ACT
Government

Further information request – DA-202442901 – Block 76 Section 10 Garran & Block 1 Section 56 Red Hill

Image 1

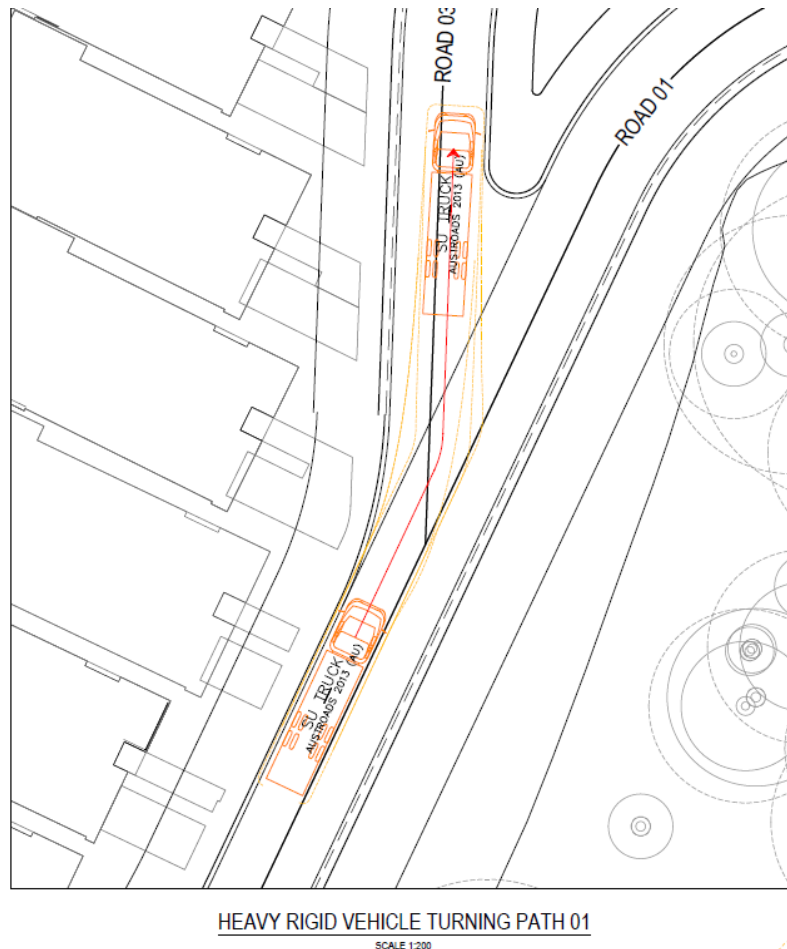
6. While the applicant has provided some Truck Turning Template (TTT), it is unclear as to whether the trucks are free to enter and exit at the same time or whether each entry and egress will be controlled so that there are not conflicts for a two-way entry and egress arrangement. For example, as shown in Image 1 below the TTT for the truck entry from Kitchener Street shows that the truck must encroach into the egress lane in order to enter. However, the applicant must explain how conflicts will be eliminated, otherwise, the verge crossing must be widened to accommodate a two-way egress and ingress without conflict.

7. The current Truck Turning Template (TTT) with a 12.5m truck non-compliant as it is encroaching over the verge crossing and the internal footpath where pedestrians can be run over as shown below.

8. All commercial waste must be stored, transferred, and collected onsite by a commercial contractor. Therefore, the applicant will need to explore the use of a smaller truck such as an 8.8m Medium Rigid Vehicle (MRV) to collect the waste and redesign the TTT to provide a fully designated parking bay, the 3m passing lane and the separation between
